PIC18F8720/8620/6720/6620 Rev. A4 Silicon/Data Sheet Errata

The PIC18F8720/8620/6720/6620 parts you have received conform functionally to the Device Data Sheet (DS39609**B**), except for the anomalies described below.

The following silicon errata apply only to PIC18F8720/8620/6720/6620 devices with these Device/Revision IDs:

FIGURE 26-3: PIC18F6620/6720/8620/8720 VOLTAGE-FREQUENCY GRAPH (INDUSTRIAL, EXTENDED)

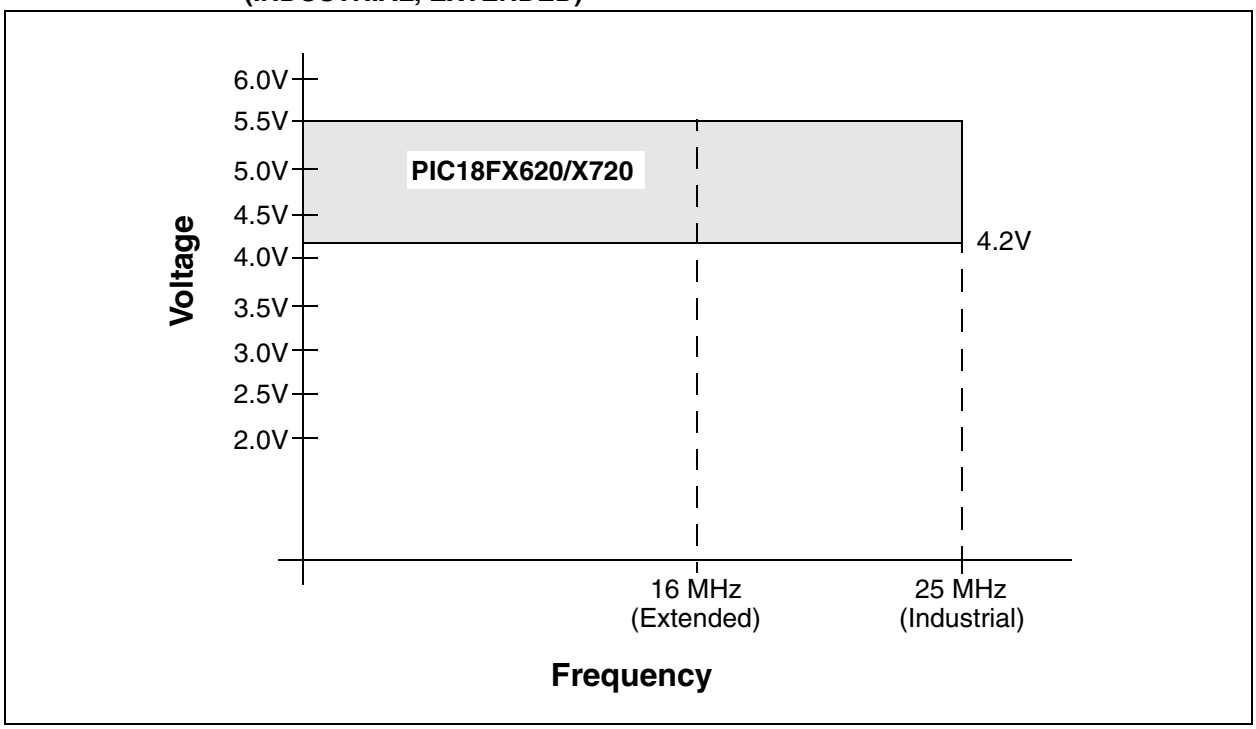
1. Module: Voltage-Frequency Graph

In **Section 26.0 "Electrical Characteristics"**, the following figure has been updated to clarify the voltage frequency for Extended devices.

FIGURE 11-1: TIMER0 BLOCK DIAGRAM IN 8-BIT MODE

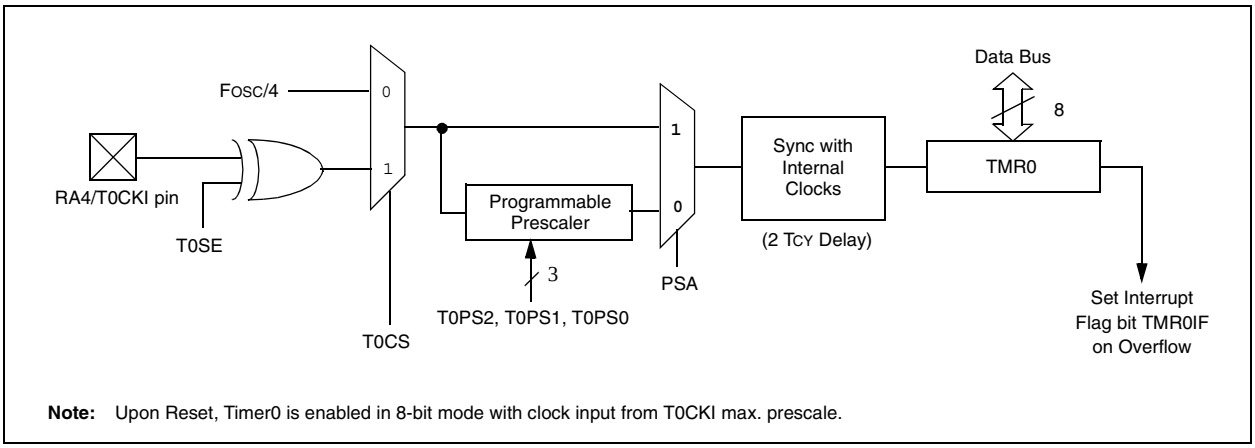
10. Module: Timer0 Block Diagram in 8-Bit and 16-Bit Modes

The PSA multiplexor bit values in Figures 11-1 and 11-2 do not match the text description of the Timer0 PSA bit in the T0CON register.

The bit values have been corrected by swapping the values as shown below (correct values are shown in **bold** text):
